ADDENDUM NO. 3

RED CLAY CONSOLIDATED SCHOOL DISTRICT
WILMINGTON CAMPUS RENOVATIONS
BID PACKAGE 'B'

Addendum No. 3 – Consists of the following:

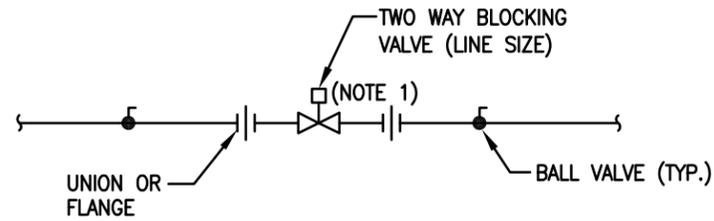
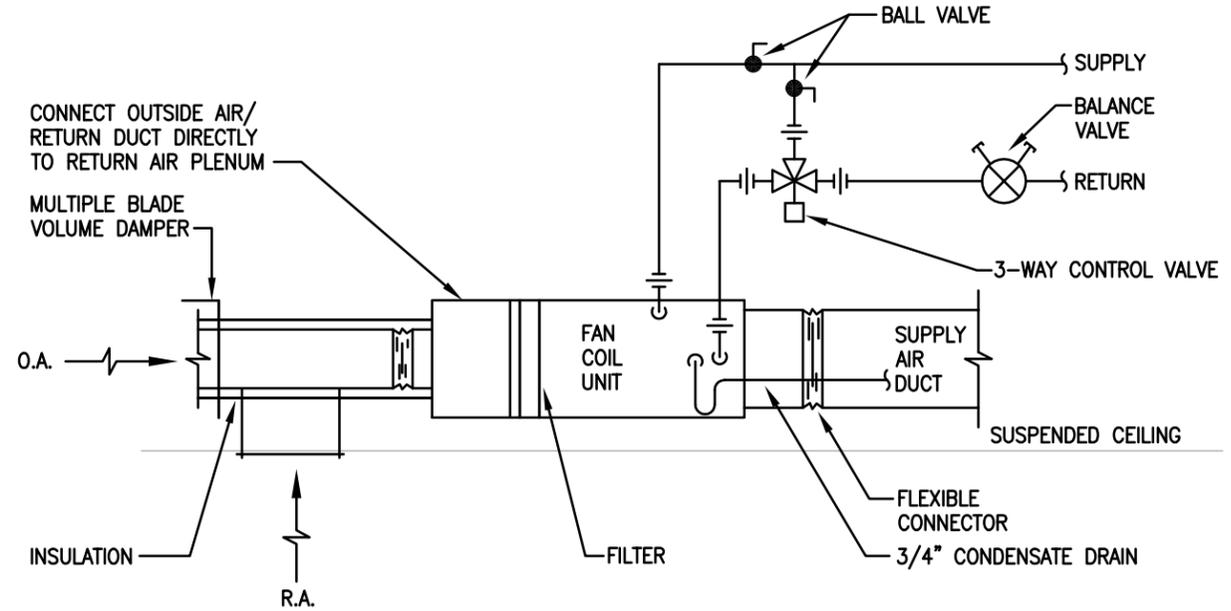
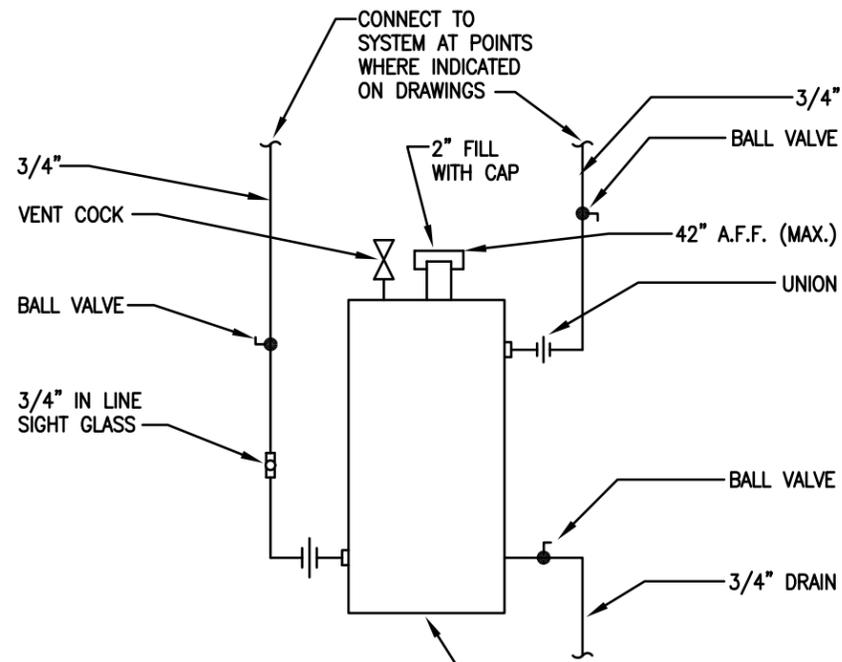
1. Add details. Refer to attached Sketch #M-709 & M-710.

2 ELECTRICAL DEMOLITION - FIRST FLOOR
 1/8" = 1'-0"

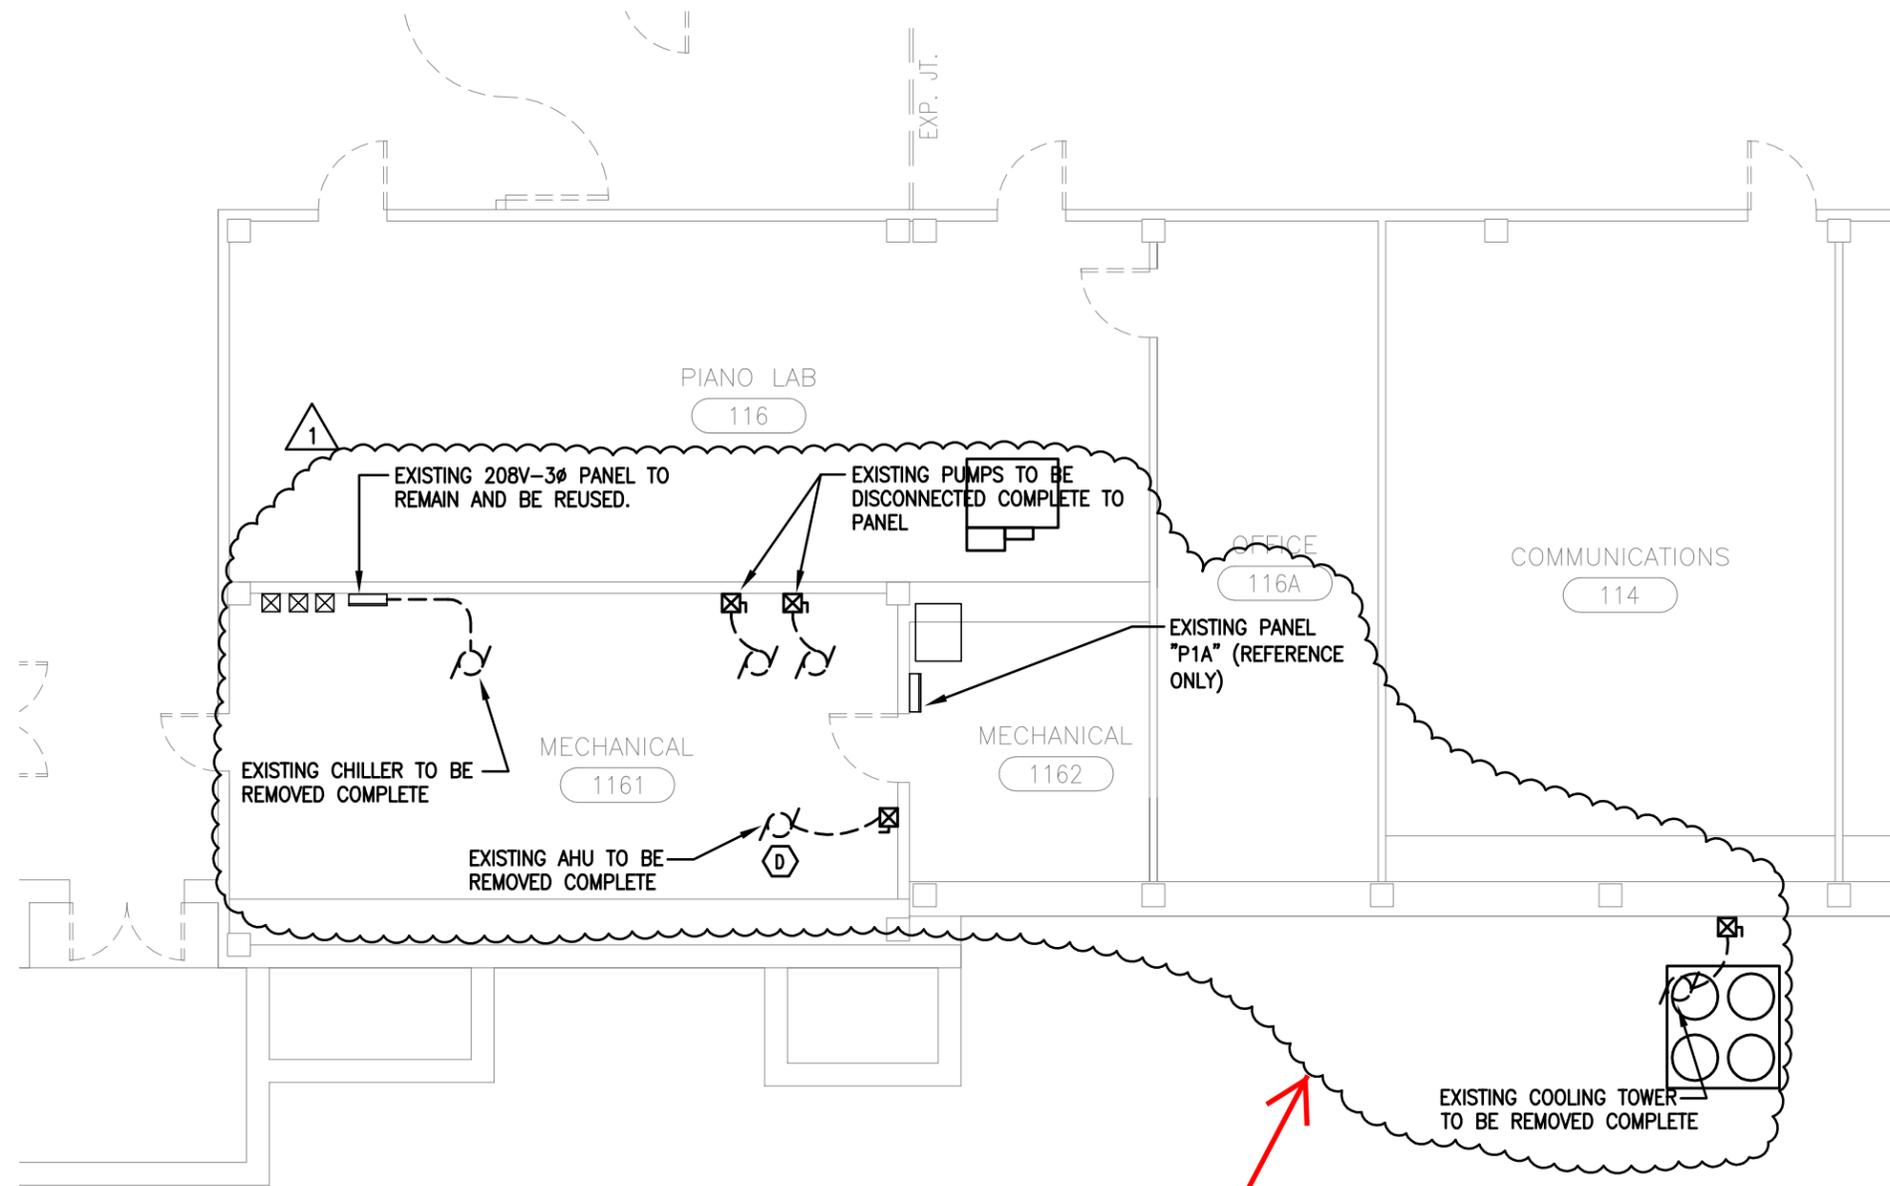
- Z. E-101 SECOND FLOOR ELECTRICAL DEMOLITION (ALTERNATE #7A)**
1. Add Demolition Plan #2 First Floor Mechanical Room 1161. Refer to attached Sketch E-700.

2 ELECTRICAL DEMOLITION - SECOND FLOOR
 1/8" = 1'-0"

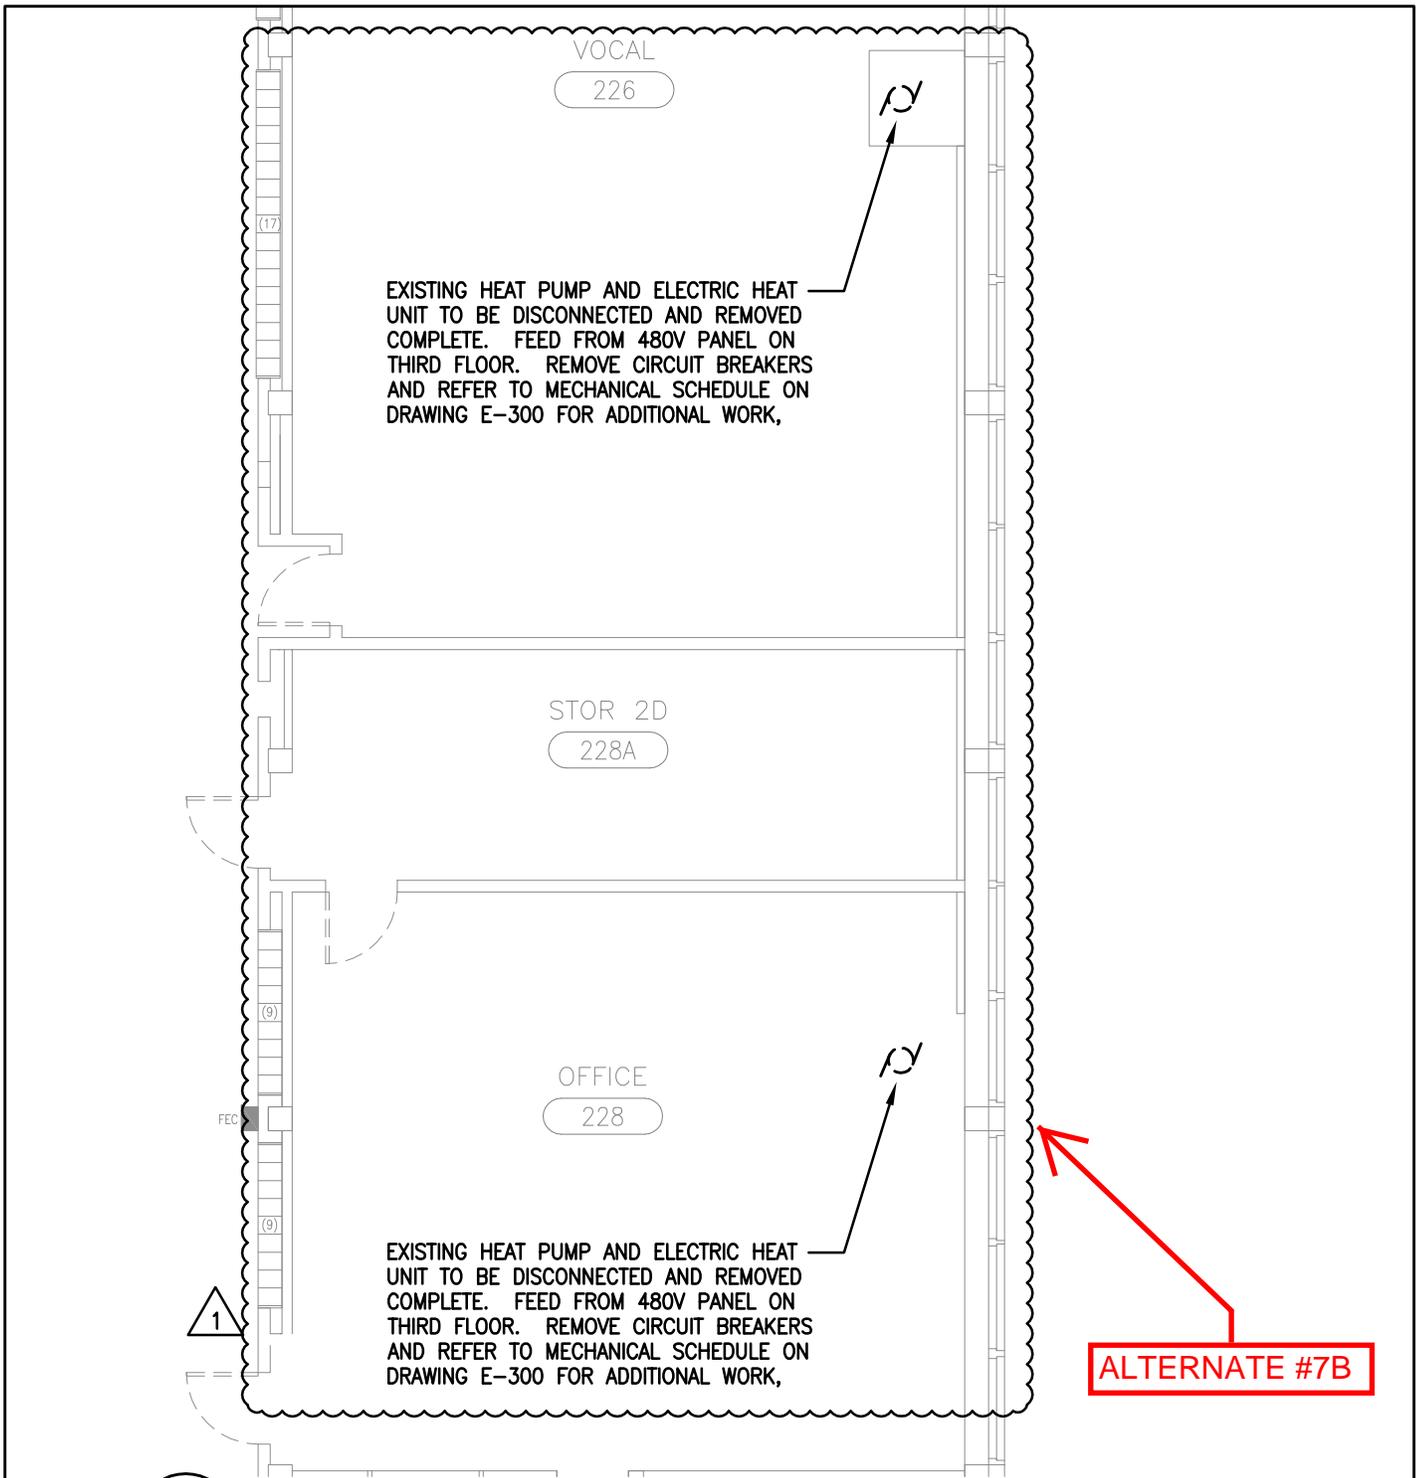
- AA. E-102 MEZZANINE ELECTRICAL DEMOLITION (ALTERNATE #7B)**
1. Add Demolition Plan #2 Second Floor Rooms 226 and 228. Refer to attached Sketch E-701.
- AB. E-103 CATWALK ELECTRICAL DEMOLITION (ALTERNATE #7C)**

2 **ELECTRICAL DEMOLITION - PARTIAL THIRD FLOOR**
1/8" = 1'-0"

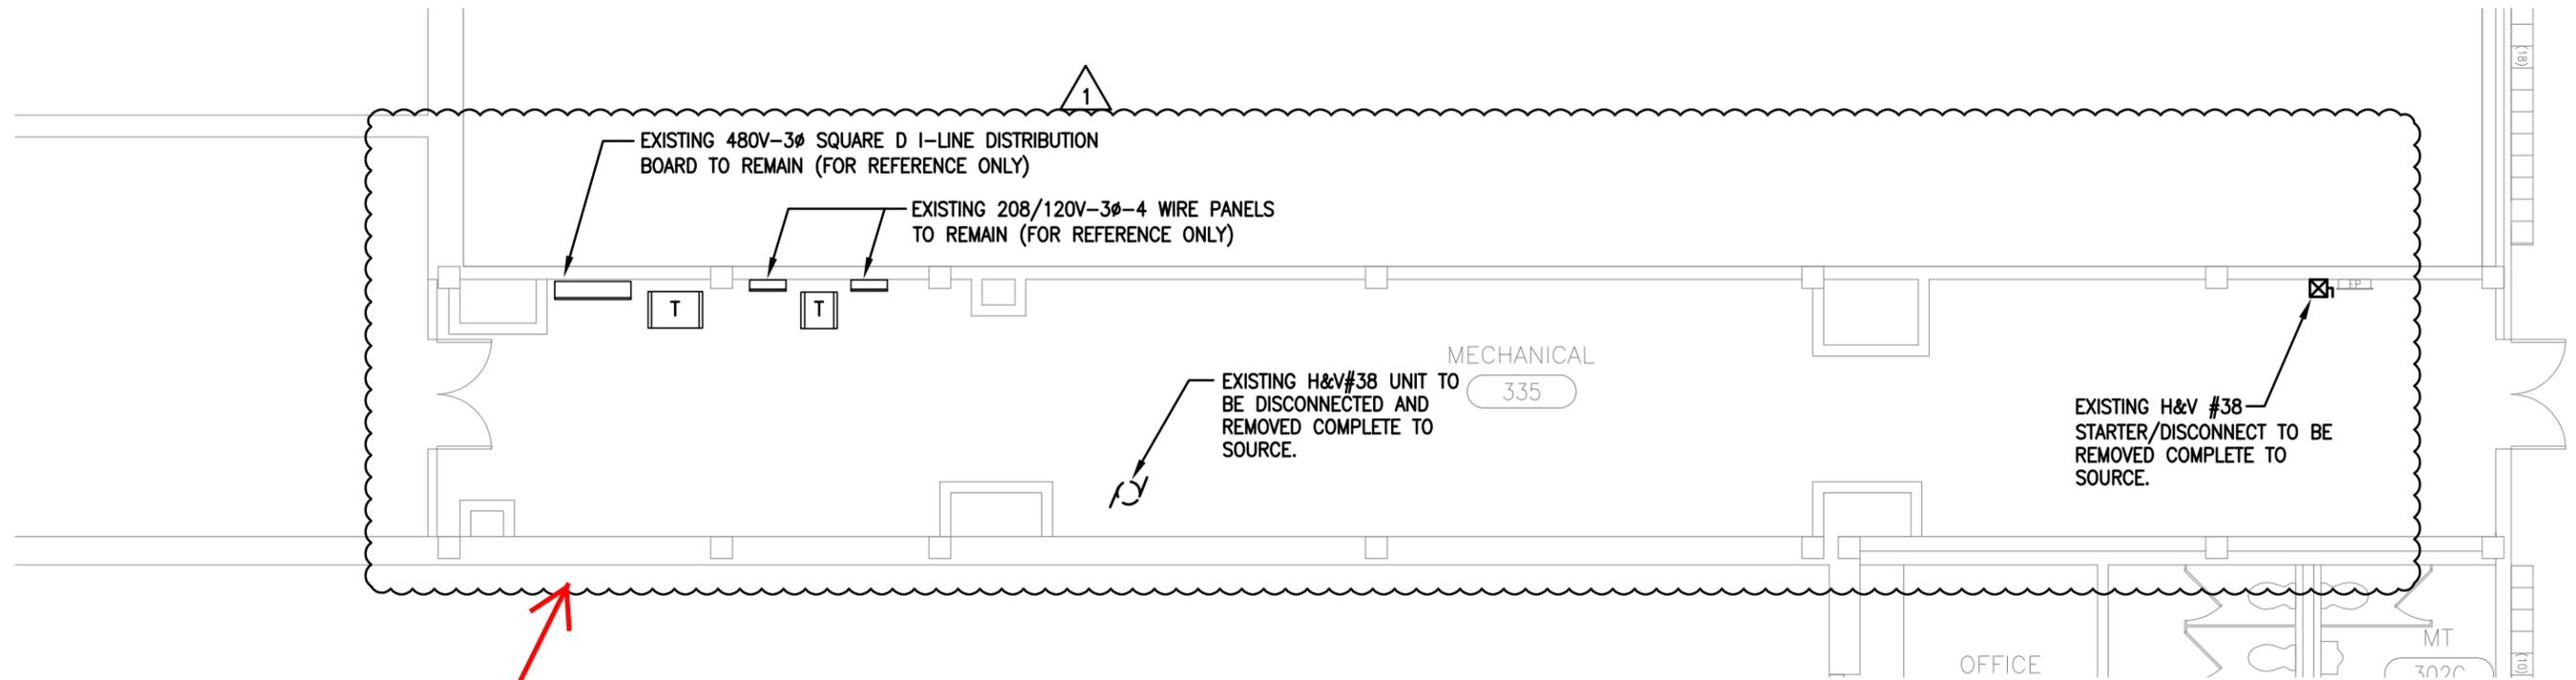
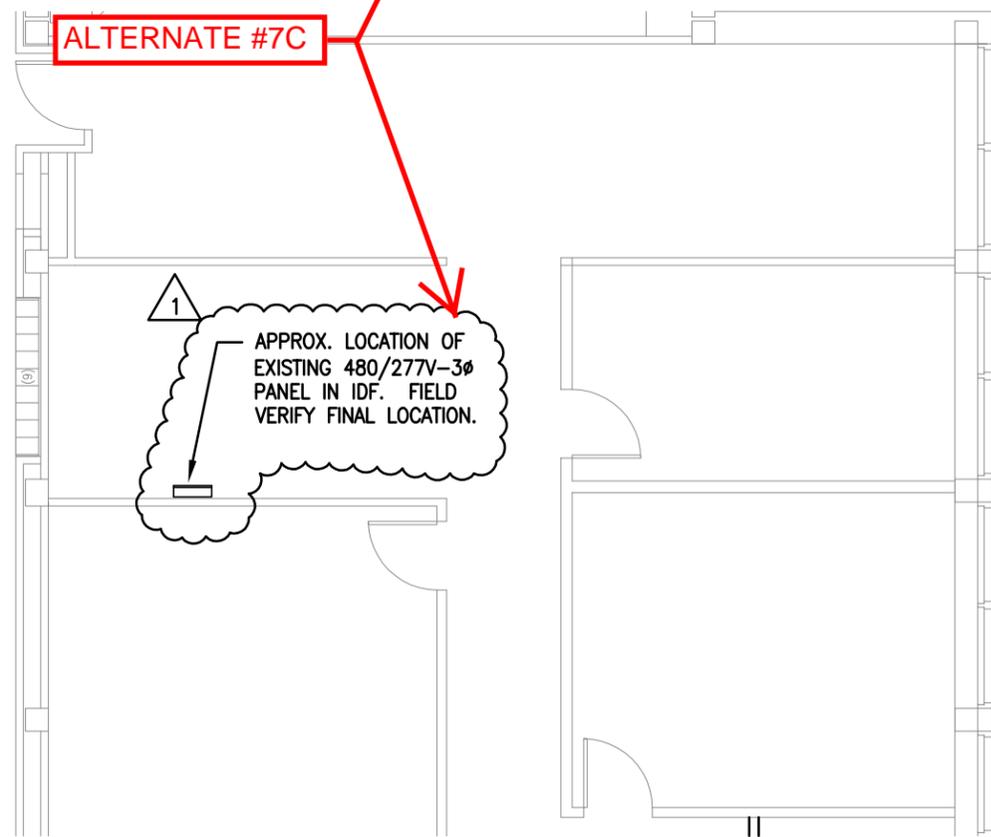
1. Add Demolition Plans #2 and #3 Third Floor Mechanical Room and IDF. Refer to attached Sketch E-702.
- AC. E-113 CATWALK ELECTRICAL LIGHTING & POWER PLANS (ALTERNATE #7C)**

2 PARTIAL POWER PLAN - THIRD FLOOR
1/8" = 1'-0"

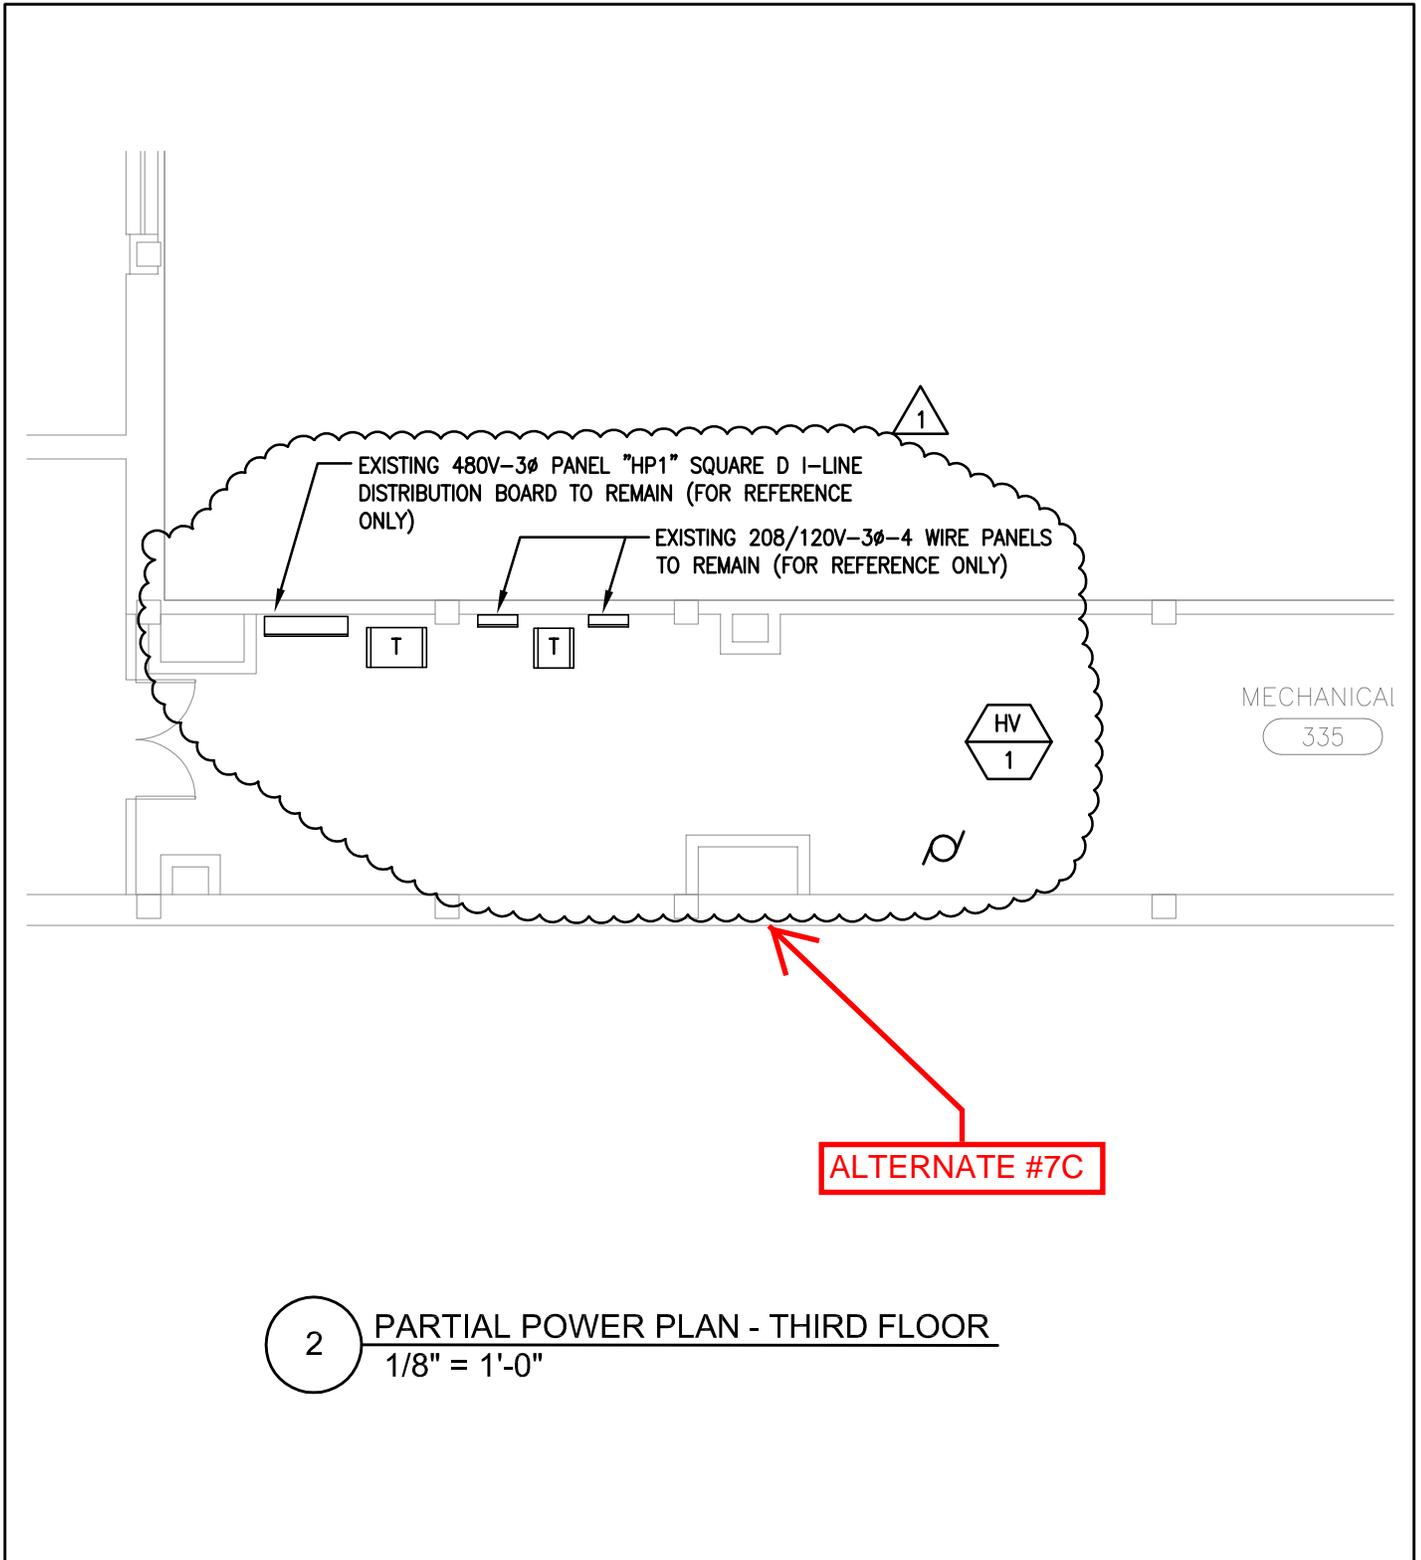
1. Add Plan #2 – Partial Power Plan Third Floor Mechanical room. Refer to attached Sketch E-703.
- AD. E-210 FIRST FLOOR POWER PLAN (ALTERNATE #7A)**
1. Add Plan #2 Partial Power Plan – First Floor Mechanical Room 1161. Refer to attached Sketch E-704.
